Serial No. 24-190
NRA/SS R0
Docket No. 50-395
License No. NPF-12

DOMINION ENERGY SOUTH CAROLINA, INC. (DESC)
VIRGIL C. SUMMER NUCLEAR STATION (VCSNS) UNIT 1
LICENSE AMENDMENT REQUEST – EMERGENCY RESPONSE ORGANIZATION
(ERO) AUGMENTATION TIME CHANGE, EMERGENCY OPERATIONS FACILITY
RELOCATION AND OTHER EMERGENCY PLAN CHANGES
SUPPLEMENTAL RESPONSE TO REQUEST FOR ADDITIONAL INFORMATION

Marked-up Emergency Plan Pages

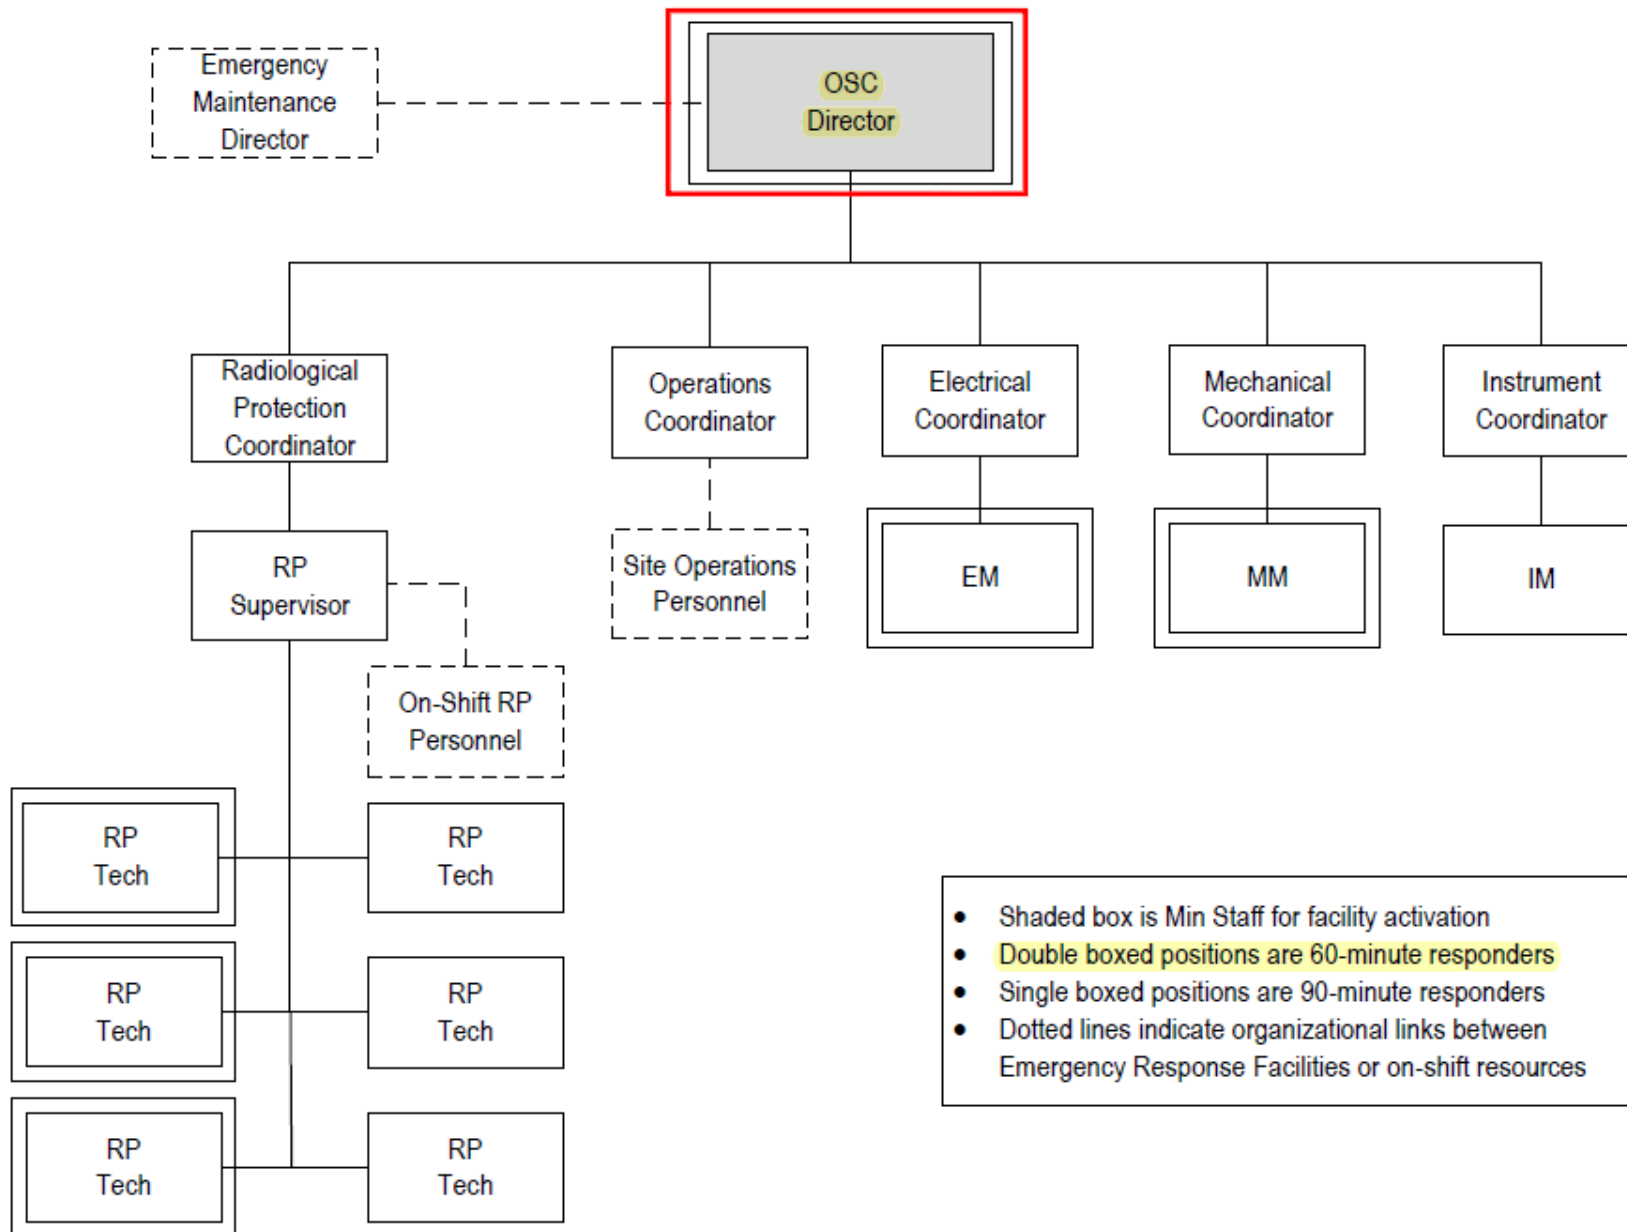
DESC also proposes to revise Table B-1a of the VCSNS Emergency Plan to assign the OSC Director position as a 60-minute responder instead of a 90-minute responder. This will allow the OSC Director to provide oversight of the 60-minute Mechanical and Electrical Maintenance responders.

These positions will provide additional support to the Shift Manager during the period between 60 and 90 minutes after an event, until augmented by the Technical Support Center (TSC) Station Emergency Manager and Technical Support Manager in the Corporate Emergency Response Center (CERC). Clean and marked-up copies of the

revised Table B-1a and Figure B-1b showing these changes are included in Attachments 2 and 3, respectively.
